Delegated Report

Planning Application No: 20240534

Location: 37 Old Road West, Gravesend DA11 0LH

Description: Formation of vehicular access and provision of one off-street parking space in front garden with associated hard standing.

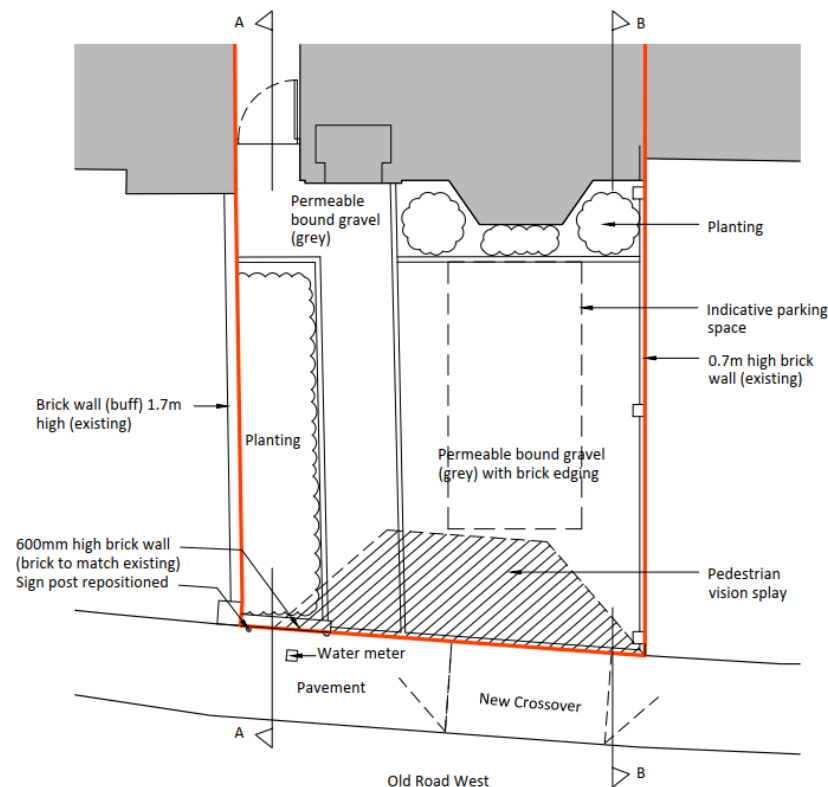
This application seeks planning permission for the formation of vehicular access and provision of one off-street parking space in front garden with associated hard standing. A revised plan has been submitted showing a pedestrian vision splay:

The proposed plans show a parking area with a planter to one side and under the bay window. The front wall will be retained to one side. There are many front driveways in close proximity that do not have any soft landscaping and these serve to demonstrate how harmful this can be on the character and appearance of the area. The proposed soft landscaping at this site will increase compared to the current situation of shingle and hard paving with minimal planting and this will complement the street scene. The loss of the front wall is regrettable however part of it will remain and will serve to demark where the footpath meets the site boundary.

The proposed driveway does not provide adequate visibility splays when exiting the driveway, particularly to the east. In addition to this, it is not possible to turn a vehicle on site, and therefore a vehicle must either reverse into the parking space or reverse onto the main road which both raise highways safety issues. Without onsite turning and sufficient visibility splays, the development is detrimental to highway safety and is therefore contrary to CS11 and CS19 of the Gravesham Local Plan Core Strategy 2014, Policy T5 Local Plan First Review (1994) and section 10.21 of the Householder Extensions/Alterations Design Guide (2021).
